**BELLA VISTA WATER DISTRICT**

## Construction Standards

Adopted: July 27, 2009  
Latest Revision February 13, 2023

The Bella Vista Water District has adopted the City of Redding Construction Standards with the specific exceptions listed below.

TYPICAL BLOWOFF  
DEAD END

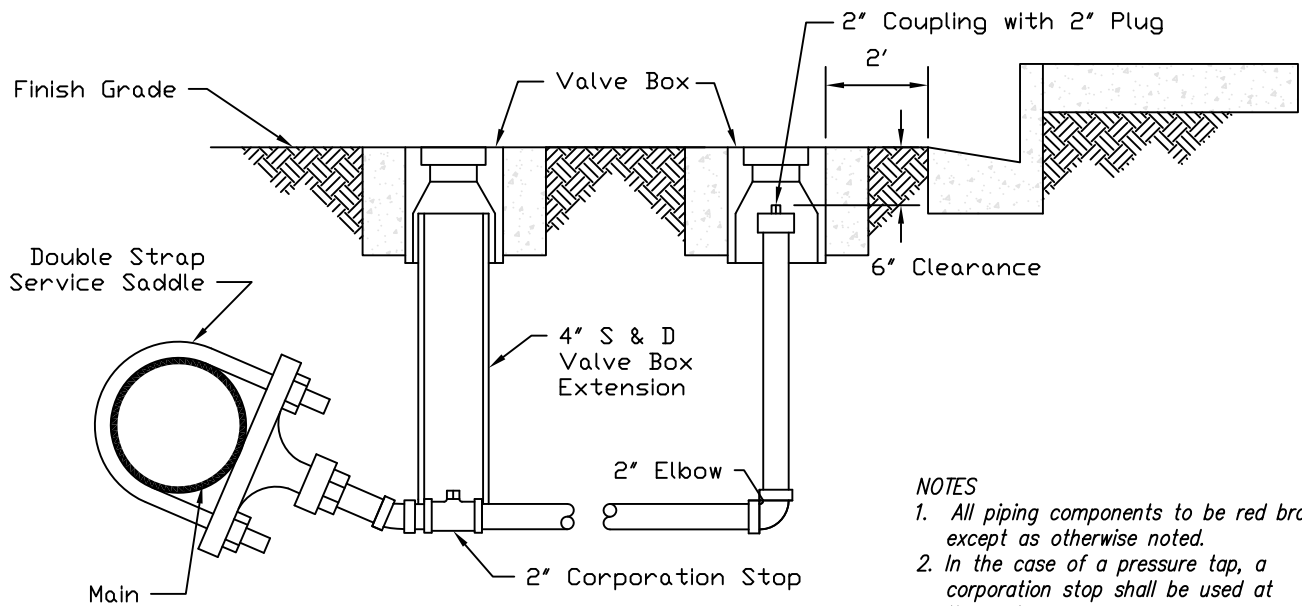
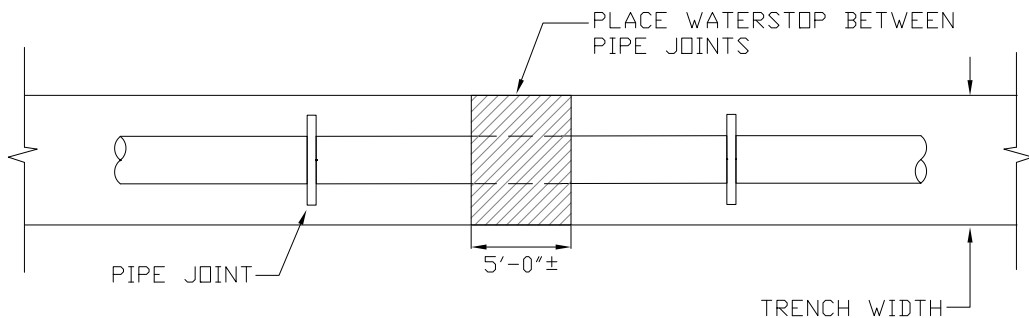
**20. PAGE 450.00 – TYPICAL BLOW-OFF INSTALLATION – DELETE City of Redding Standard 450.00 and REPLACE with the attached BVWD drawing titled “Typical Installation – 2” Blowoff Assembly.”**

1. All piping components to be red brass except as otherwise noted.
2. In the case of a pressure tap, a corporation stop shall be used at the main.
3. Size blowoff according to California Waterworks Std. Title 22.
4. Replaces City of Redding Standard 450.00

Dwg. Date: 4/3/14		SCALE NTS	BELLA VISTA WATER DISTRICT	
			APPROVED BY	TYPICAL INSTALLATION WATERSTOP FOR TRENCHES

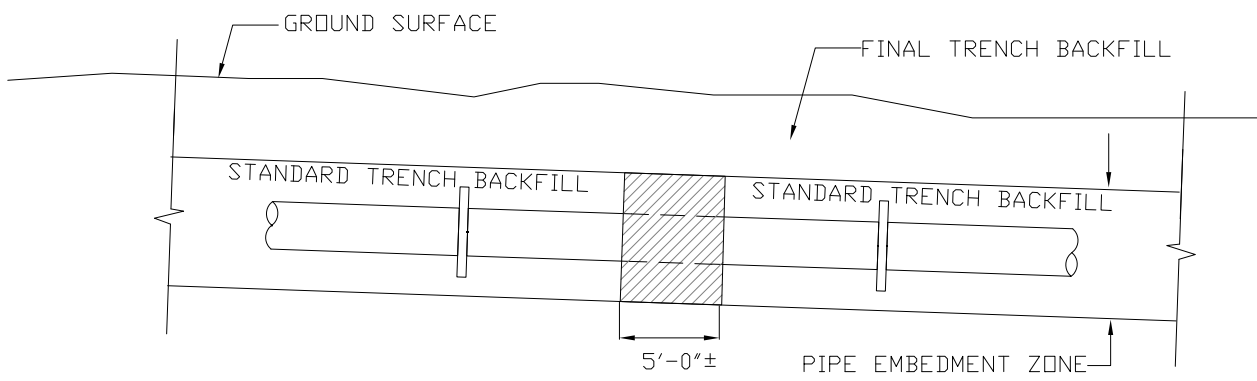
**22. WATERSTOPS** – Waterstops shall be placed when and where shown on the plans or as specified in the contract drawings. See attached detail titled “Typical Installation – Waterstop for Trenches.”

- NOTES:**
1. PLACE CLAY WATERSTOP IN TRENCH AS SHOWN TO PREVENT WATER FLOW THROUGH GRANULAR TRENCH BACKFILL. COMPACT CLAY WATERSTOP TO MINIMUM 95% DENSITY.
  2. IF STABILIZATION (FOUNDATION) MATERIAL IS REQUIRED, EXTEND WATERSTOP THROUGH STABILIZATION MATERIAL TO BOTTOM OF TRENCH.
  3. BACKFILL REQUIREMENTS ABOVE WATERSTOP (FINAL TRENCH BACKFILL) SHALL BE IN ACCORDANCE WITH THE CITY OF REDDING CONSTRUCTION STANDARDS, PAGES 610.00 (TRENCH BACKFILL) AND 611.00 (TRENCH RESURFACING DETAILS).
  4. WATERSTOPS ARE REQUIRED ONLY WHEN SPECIFIED IN THE CONTRACT DOCUMENTS. WHEN REQUIRED, WATERSTOPS SHALL BE PLACED AT A NOMINAL SPACING OF 800' OR AT LOCATIONS SHOWN ON THE PLANS.
  5. WHEN SUITABLE CLAY MATERIAL IS AVAILABLE ON-SITE, INSTALLATION OF WATERSTOPS SHALL BE CONSIDERED INCIDENTAL.

**TYPICAL SERVICE CONNECTION**

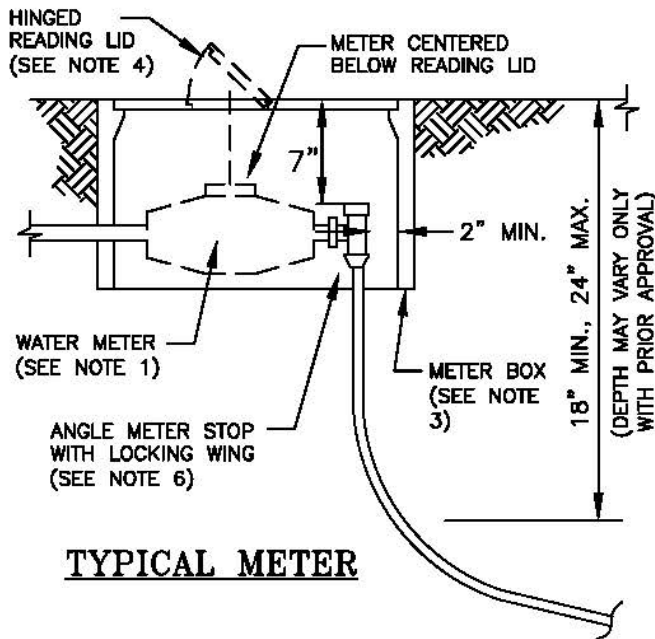
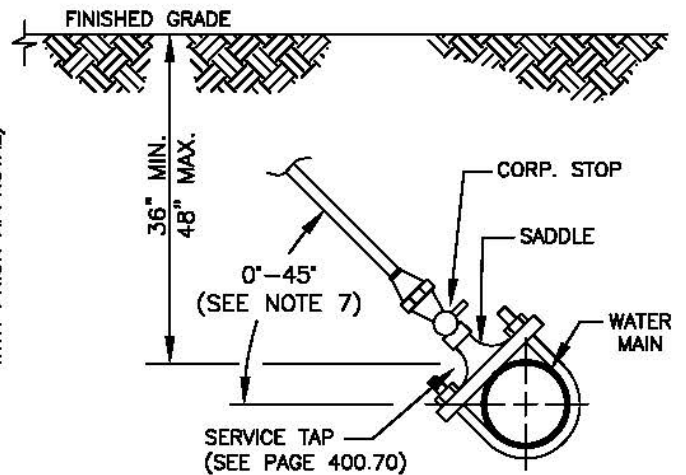
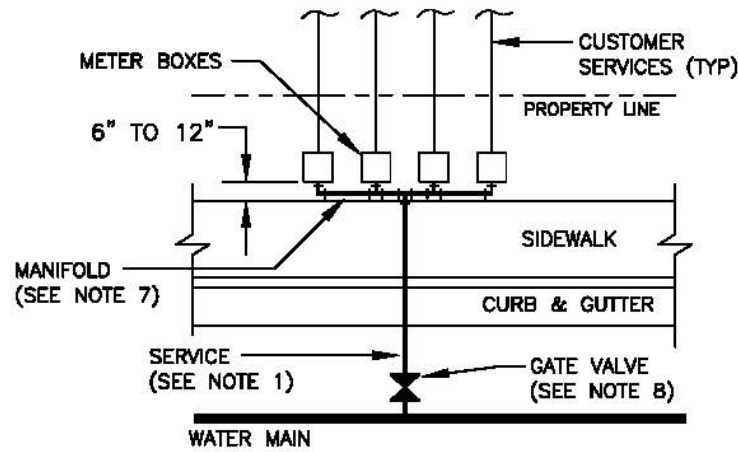
**6. PAGE 401.00 – WATER SERVICE CONNECTION**

DELETE all references to Double Service connections.

On note 1, DELETE: “Service connection charges shall be for a Class 30 meter, unless resident requires a larger domestic connection, then the greater connection charges shall apply.”

DELETE note 7 and replace with “All services shall be tapped 0° from the horizontal.”

**CASE I**

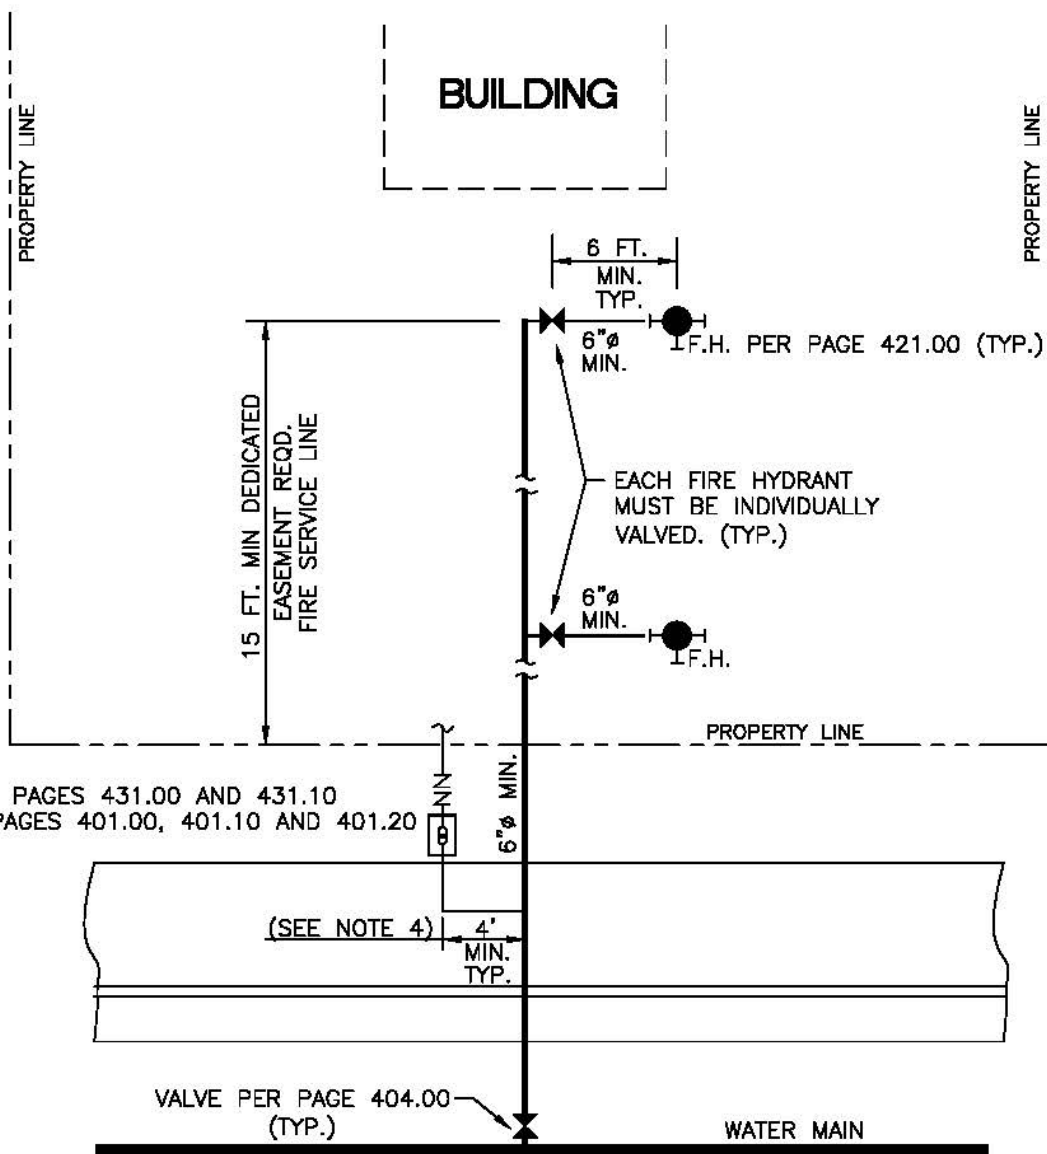
**11. PAGE 422.01 – FIRE SERVICES (TYPICAL) CASE I** – MODIFY the drawing as follows:

The shut-off valve on the fire service line shall be located at the connection to the water main. For all dedicated fire sprinkler services an approved RPPDA type backflow device shall be installed at the point of connection (P.O.C.) at the property line. The backflow device and the fire service line downstream of the backflow device shall be the responsibility of the property owner.

**CASE III**

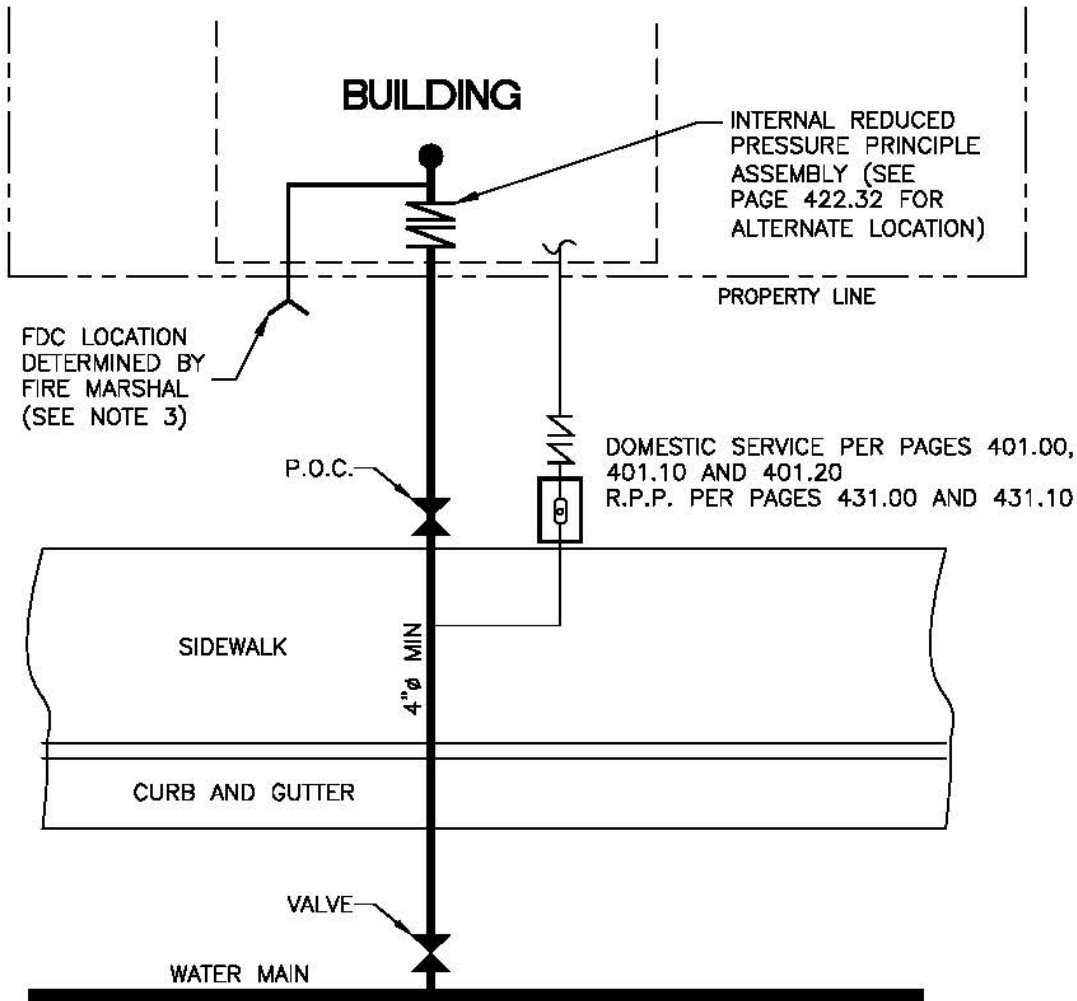
**13. PAGE 422.03 – FIRE SERVICES (NON-TYPICAL) CASE III** – DELETE this drawing in its entirety. This type of fire service is not allowed within the Bella Vista Water District water system.
